PSE - OPERATIONAL TRAINING CENTER

CIVIL CONSTRUCTION PERMIT

CIVIL COVER SHEET

C0.0

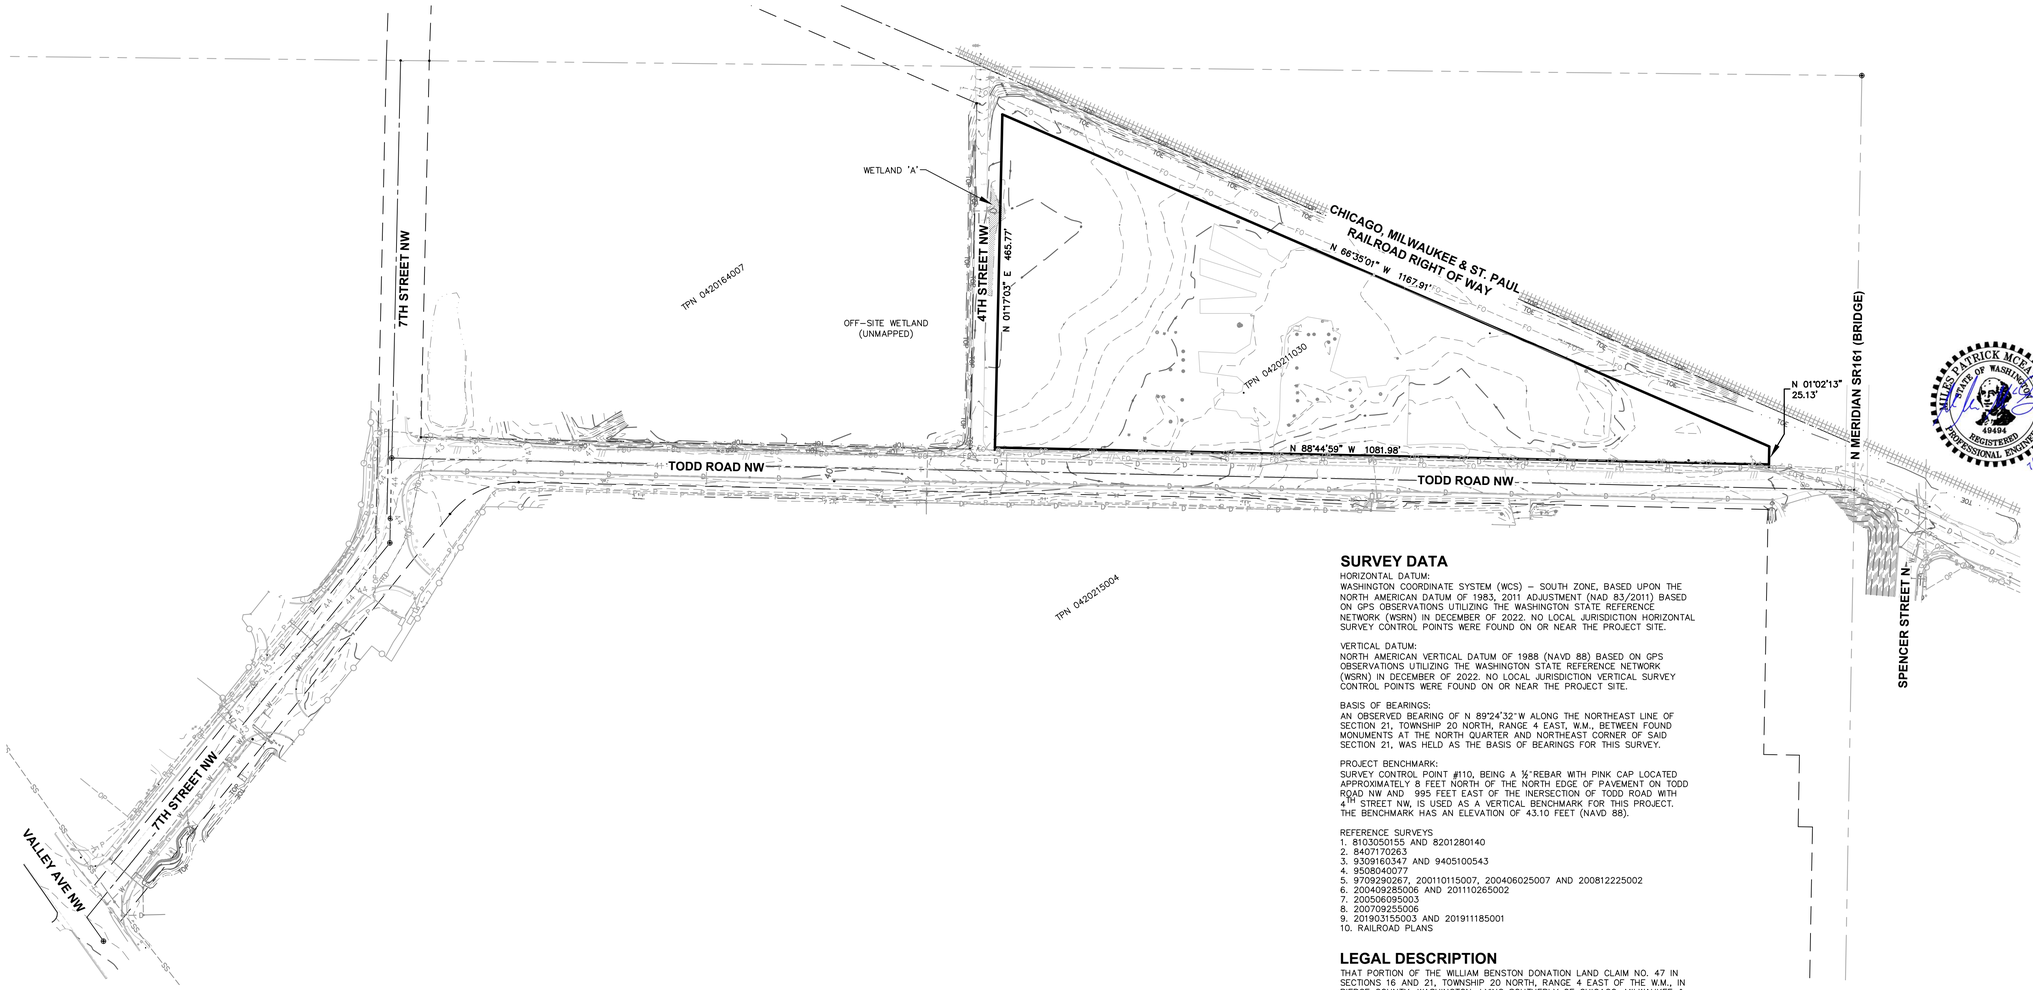
An Archaeological Monitoring Plan and Inadvertent Discovery Protocol (MIDP) has been prepared for this project. These plans shall be updated to reference the MIDP and provided the necessary notes regarding coordinating with Archaeological Monitors. (C0.0)

C1.2A

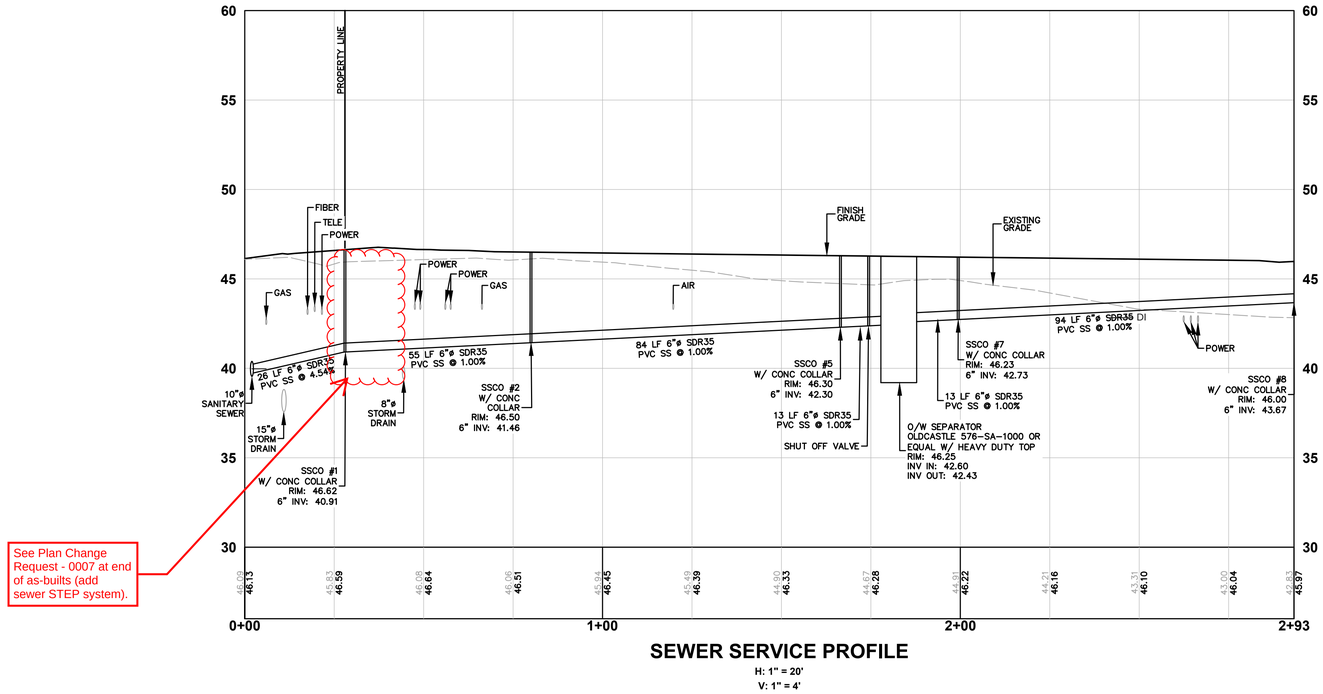
See Plan Change Request - 0007 at end of as-builts (add sewer STEP system).

PLAN CHANGE REQUEST - 0006

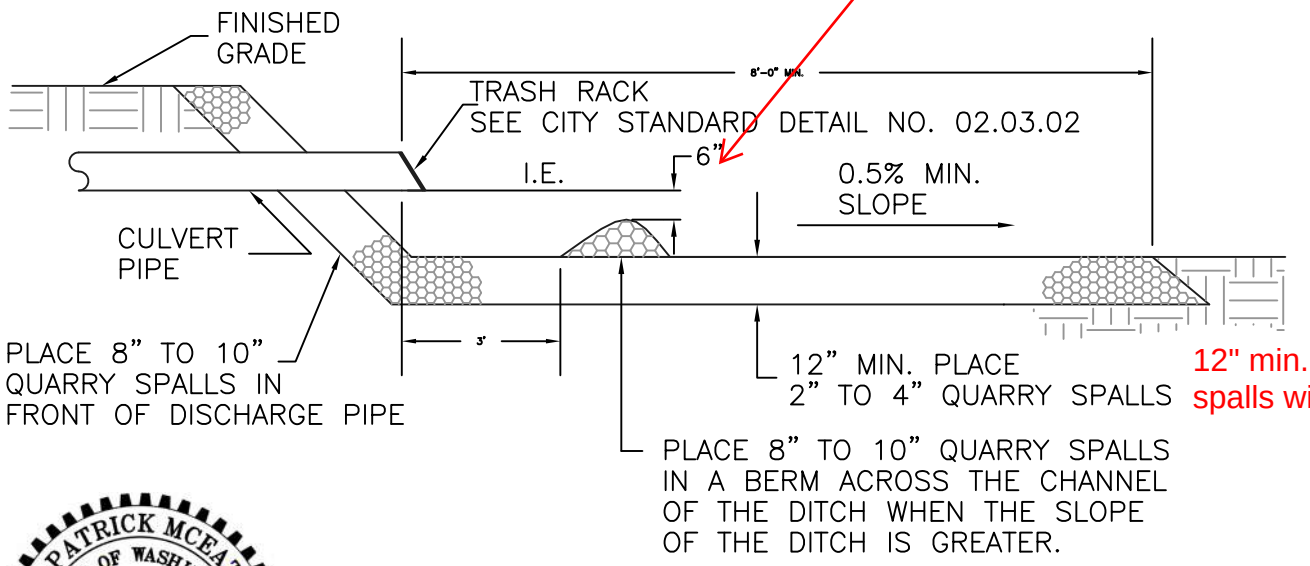
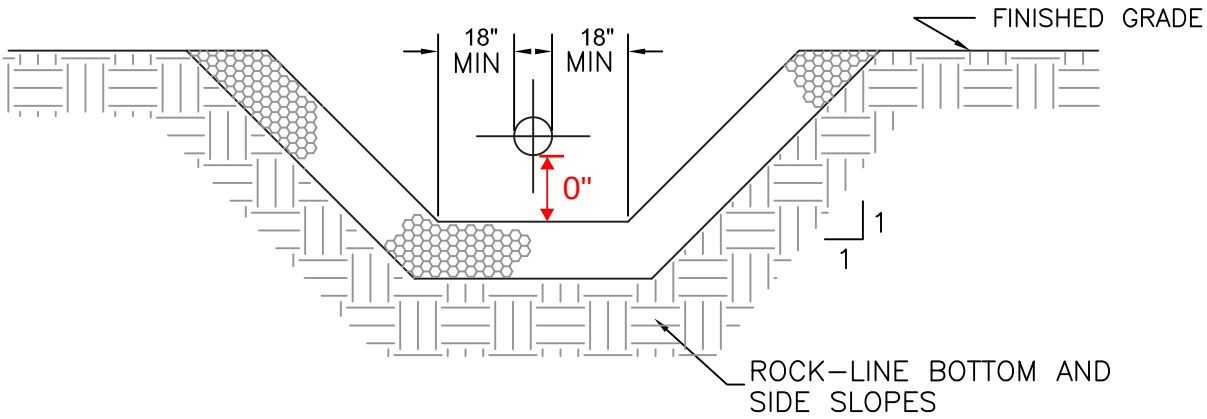
N/A, berms not provided.

12" min. depth of spalls will be at d

Slope is not greater than 0.5%, quarry spall berms are not required.
